# Sewerage & Water Board OF NEW ORLEANS

## Addendum No. 6

Your reference is directed to **Contract Number: 2025-SWB-67 (30270)** for East Bank Water Treatment Plant Upgrades which is scheduled to open at **11:30 a.m. CST on March 12, 2026.**  
This addendum provides for the following:

## EAST BANK STP PHASE IA – SECONDARY TREATMENT UPGRADE

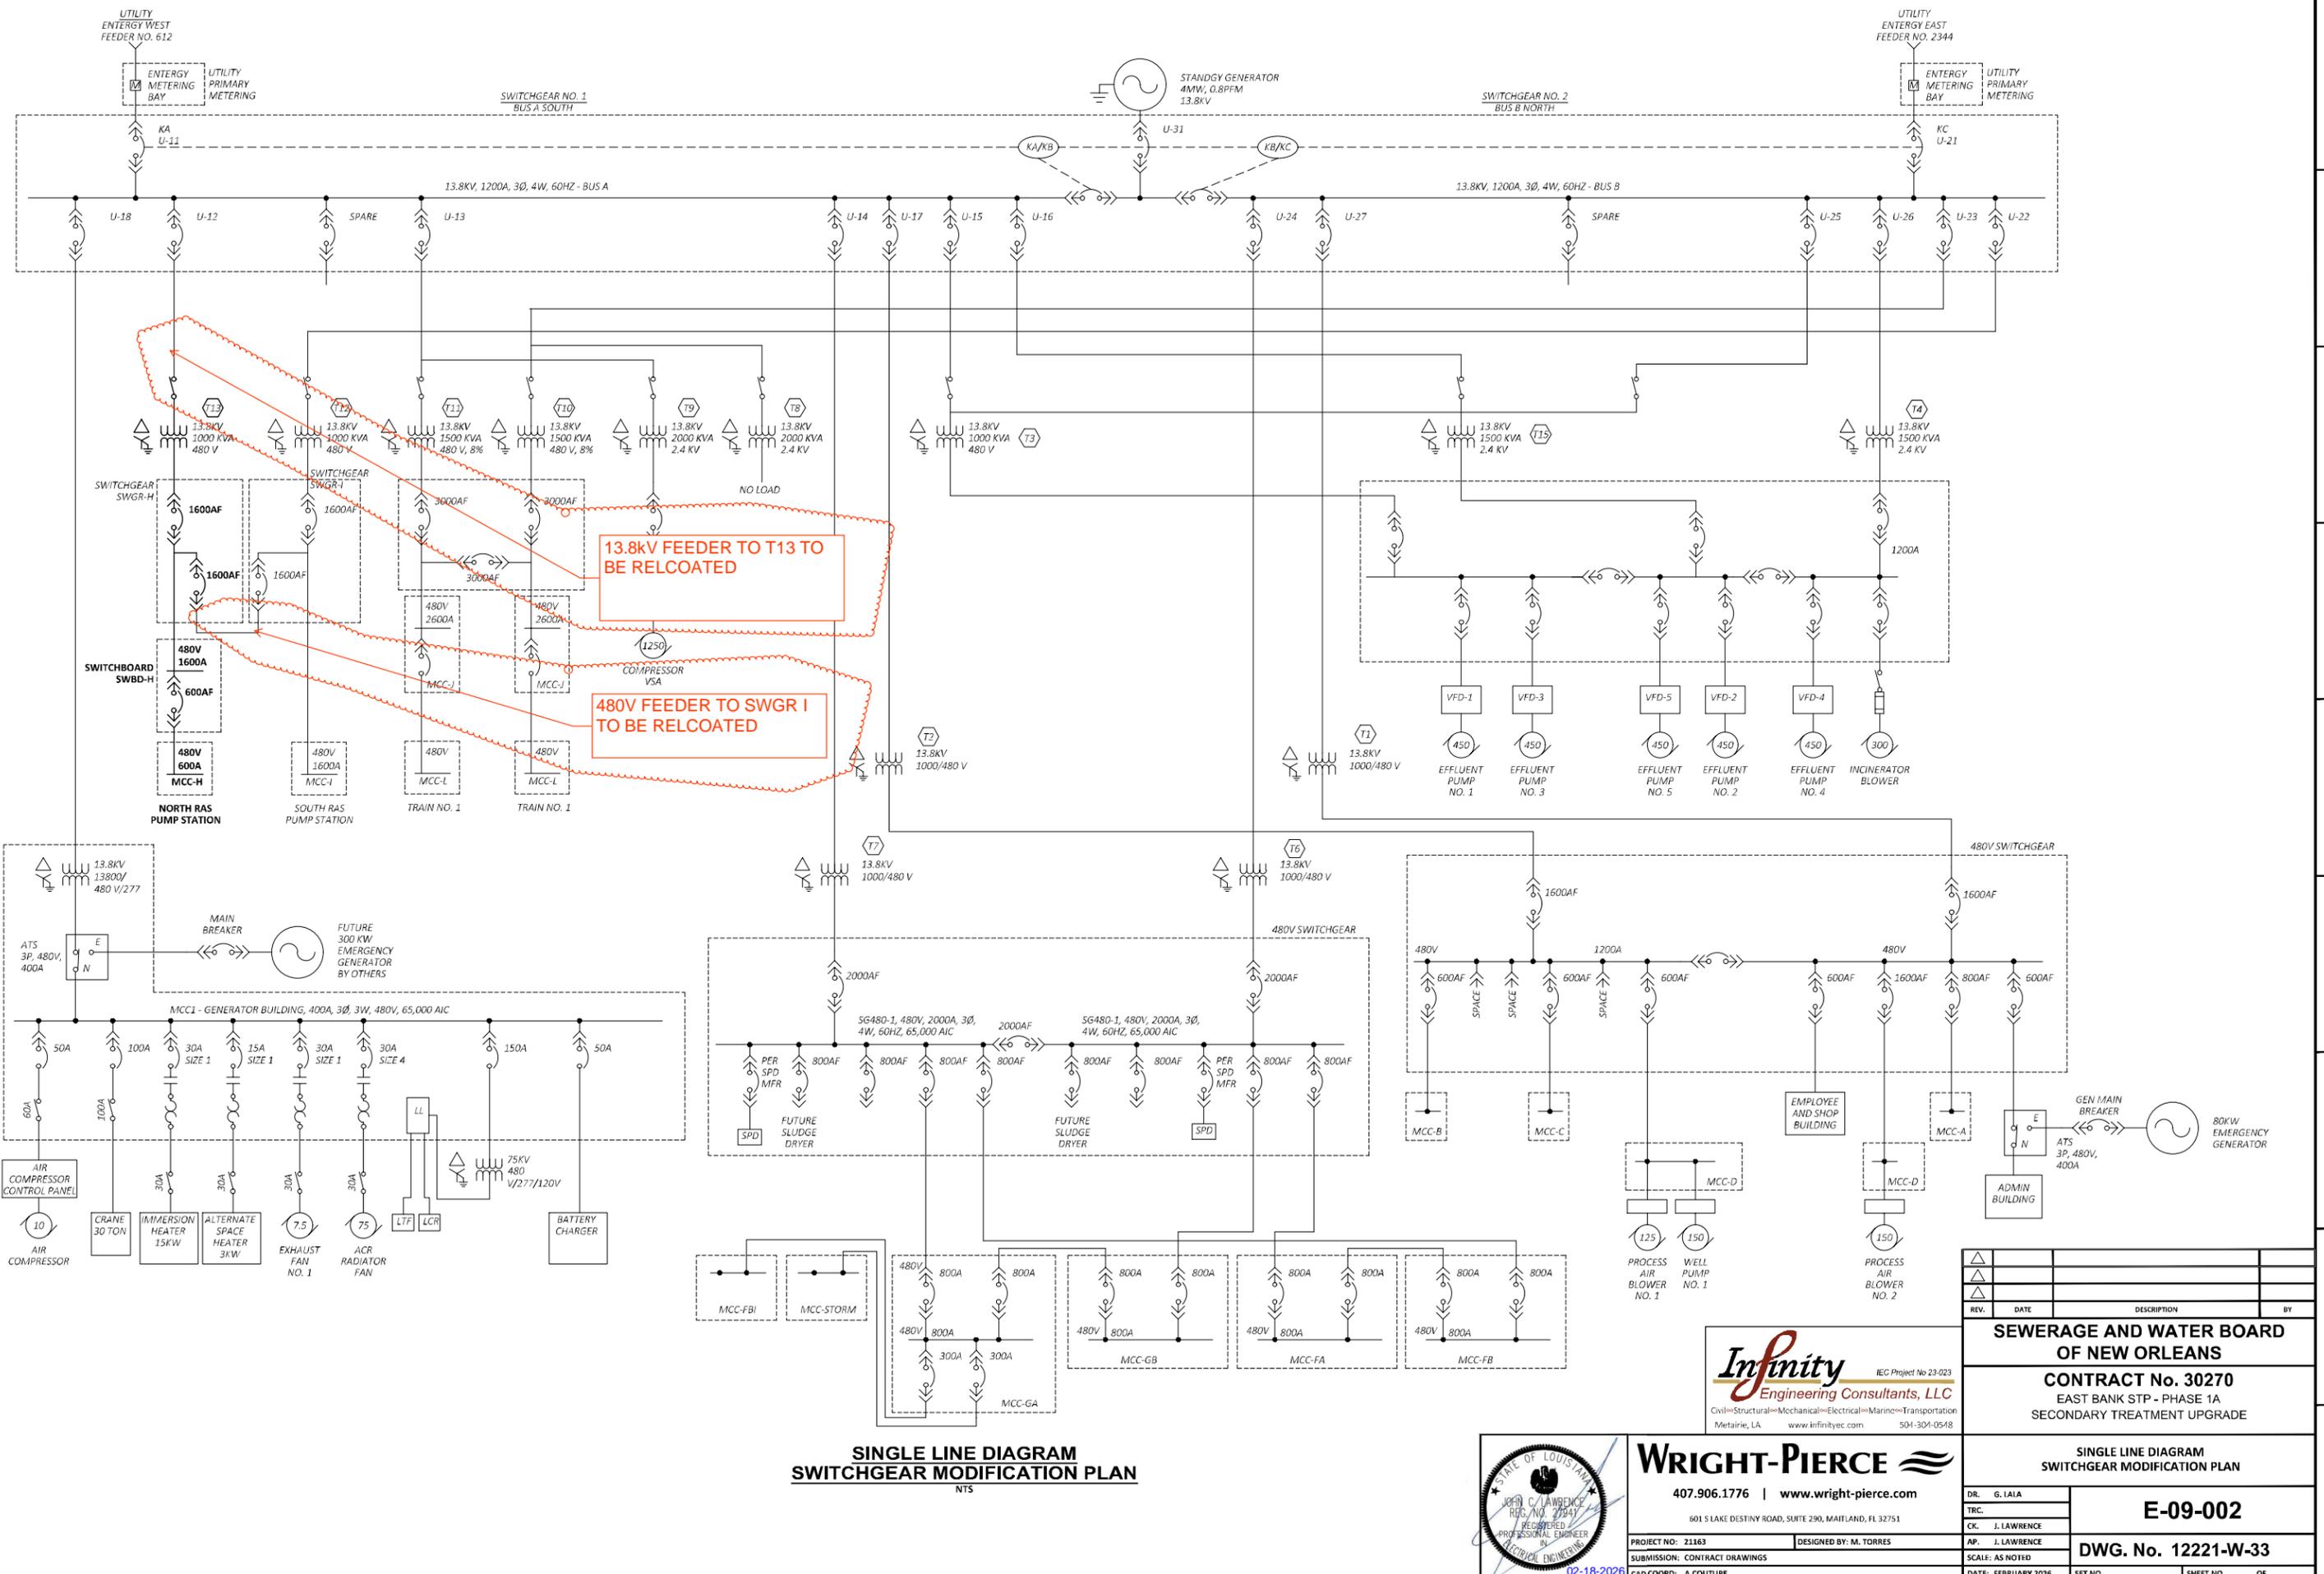
1. In Drawing, S-52-301, North RAS Pump Station Sections 1, under Section 8, **DELETE** “Notes 1, 2 and 3” in their entirety. Refer to the attached drawing in this addendum for additional information.
2. In Drawing, E-09-002, Single Line Diagram, Secondary Modification Plan, **MAKE** the following modifications:
  - **ADD** reference note “13.8kV Feeder to T13 to be relocated”
  - **ADD** reference note "480V Feeder to SWGR 1 to be relocated”
  - Refer to the attached drawing in this addendum for additional information.
3. In Drawing, E-52-101, Electrical Plan North RAS Pump Station, **MAKE** the following modifications:
  - **ADD** reference note “13.8kV Feeder to T13 to be relocated to new location for T13”
  - **ADD** reference note “New Transformer T13”
  - **ADD** reference note "New 15kV Switch for T13”
  - Refer to the attached drawing in this addendum for additional information.

7. The demo note on sheet E-52-101 states to pull back and reroute the 15KV feeders to the new switch location. Please identify the location of the feeder source and routing to determine footage. Will splices be allowed if the feeders are not long enough to reach the new location?

*The 15kV feeder is to be routed from the existing location of transformer T13 to the new location of T13. T13 is fed from SWGR #1 Bus A. Refer to Drawings, E-09-002, Single Line Diagram, Switchgear Modification Plan, and E-52-101, Electrical Plan North RAS Pump Station, attached to this addendum for additional information. Lastly, Splices are allowed if necessary. No splices will be allowed on the project.*

**ELECTRICAL PLAN NORTH RAS PUMP STATION**

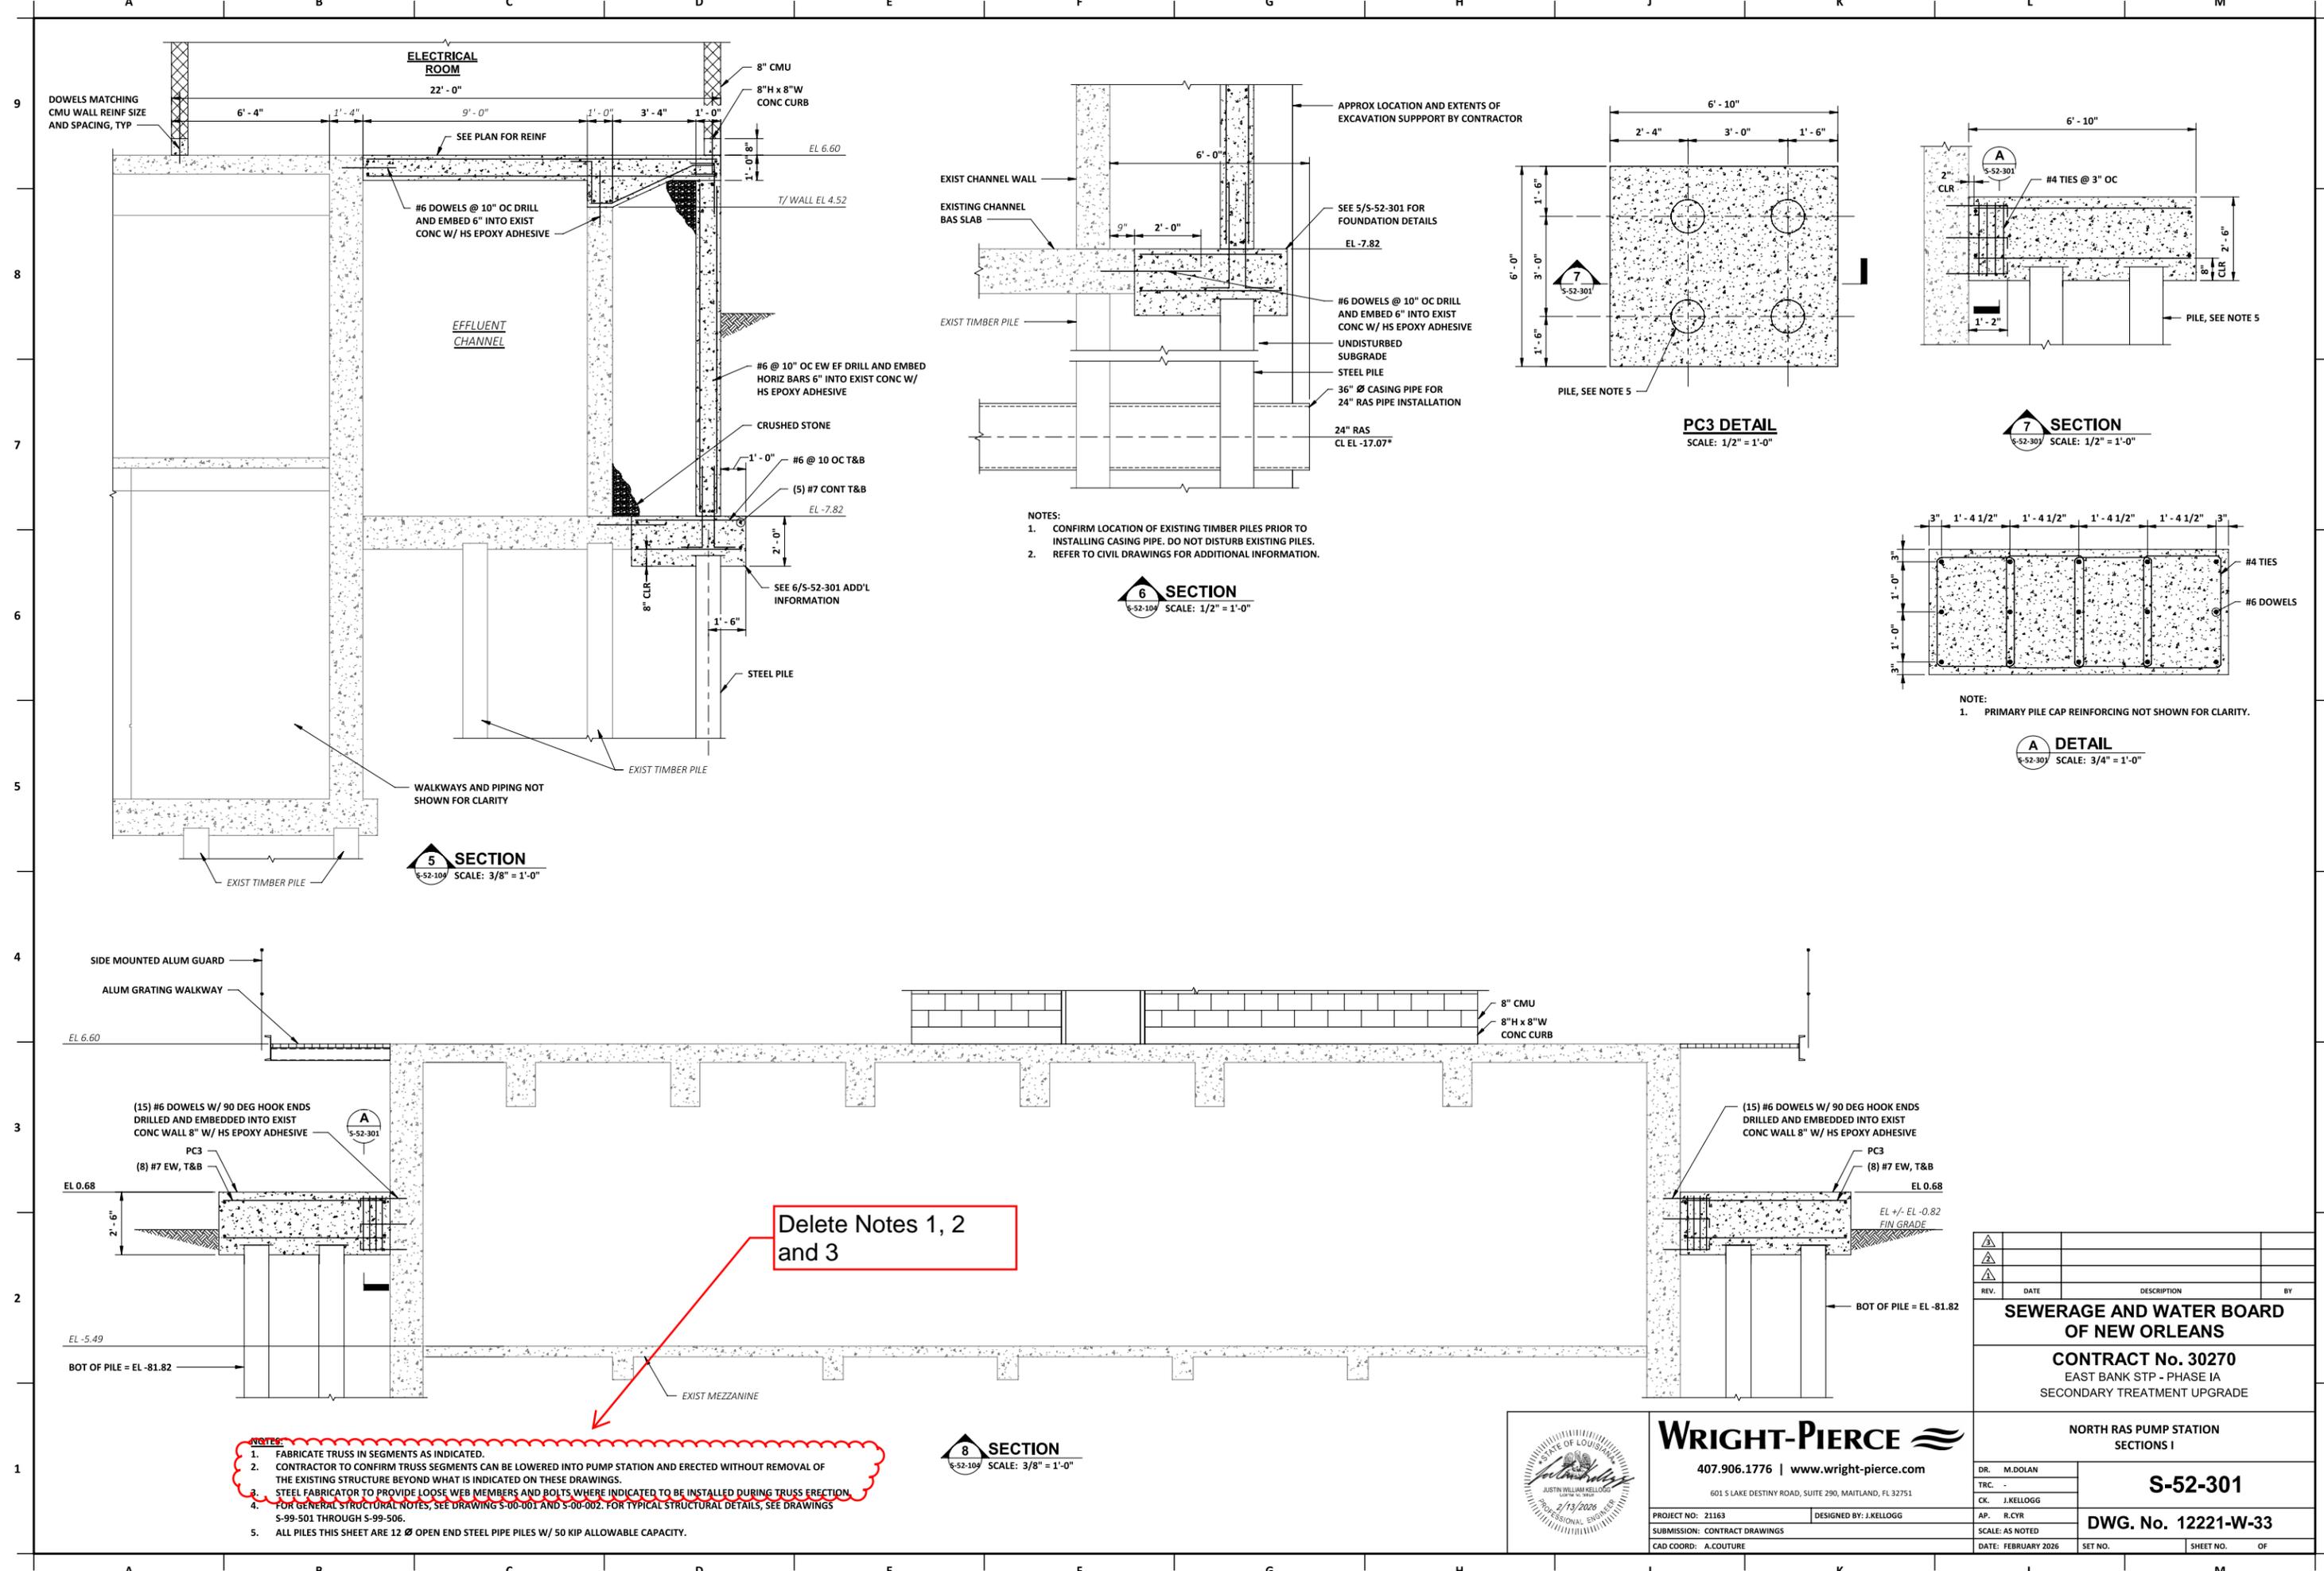
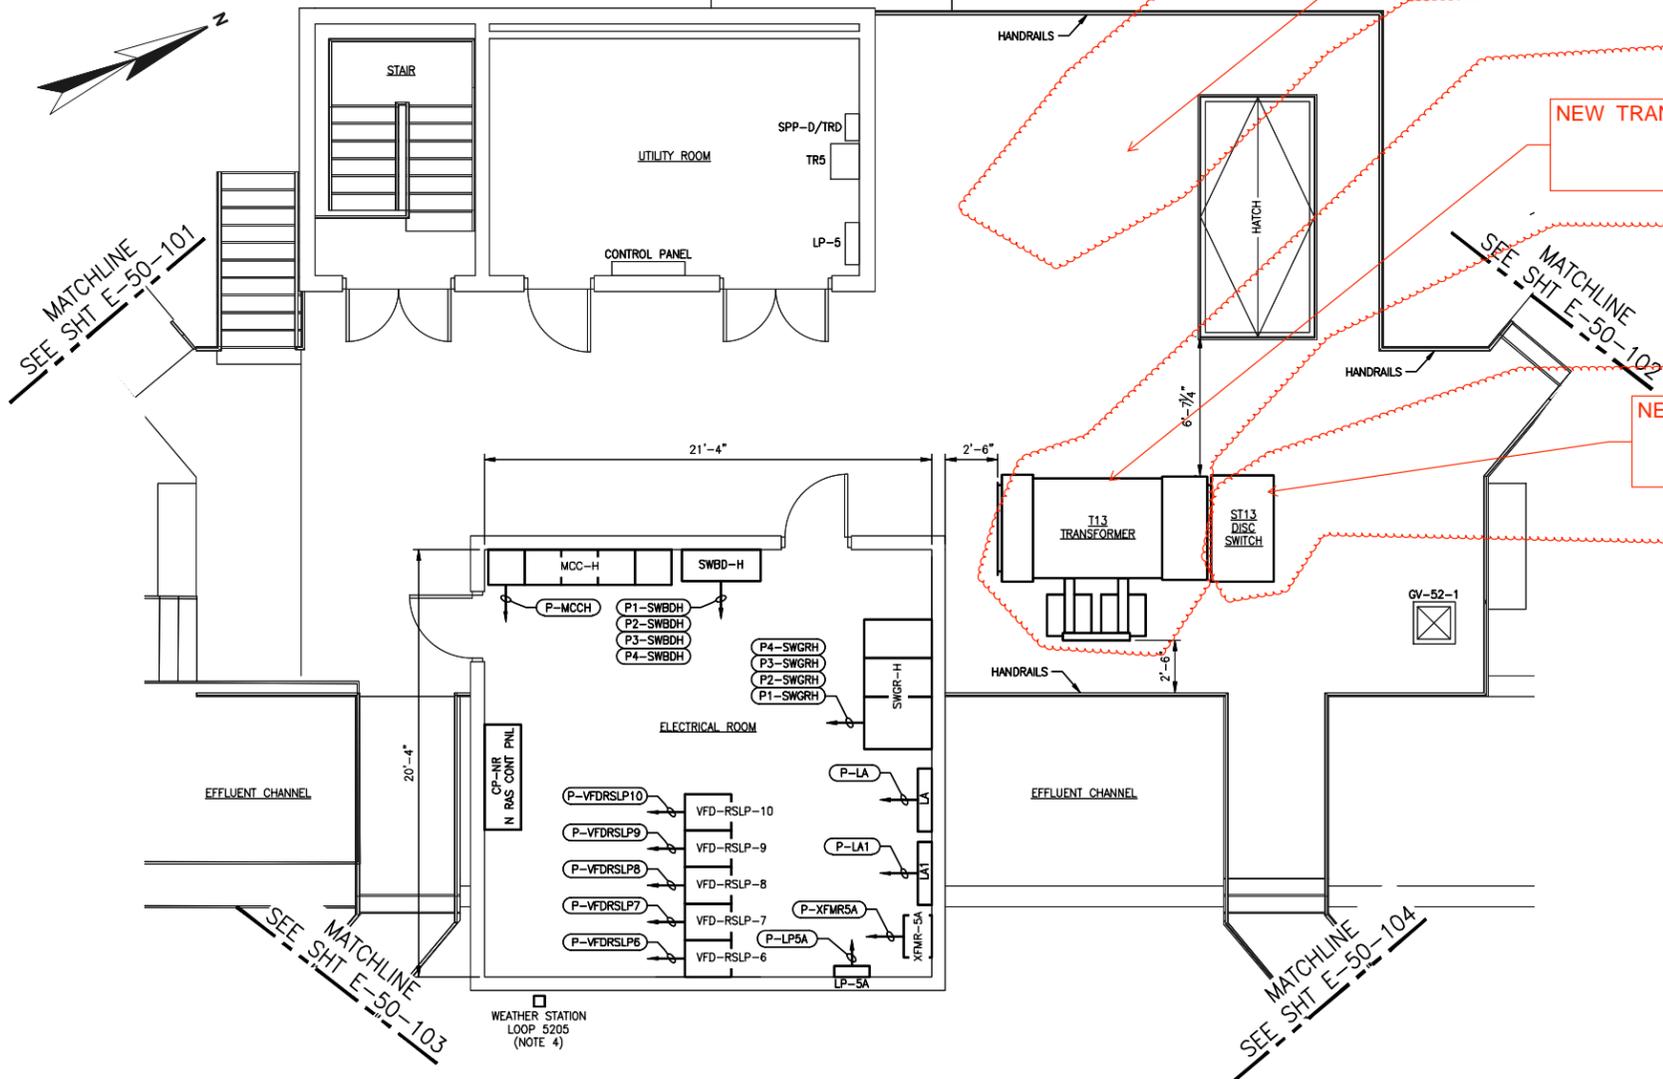
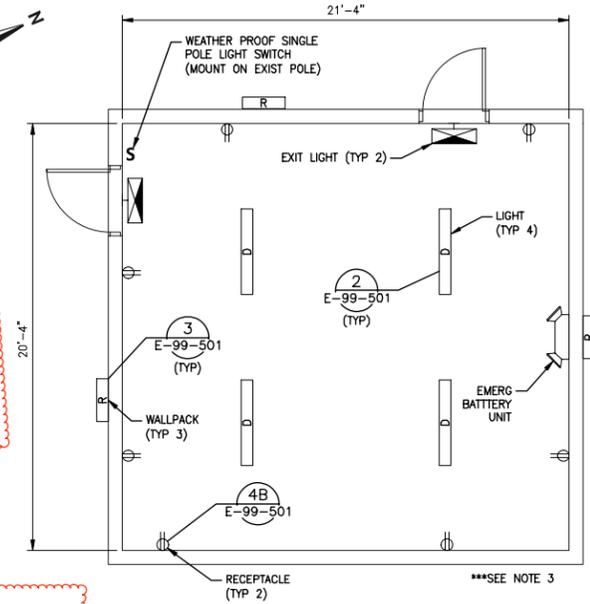
13.8kv FEEDER TO T13 TO BE RELOCATED TO NEW LOCATION FOR T13

NEW TRANSFORMER T13

NEW 15KV SWITCH FOR T13
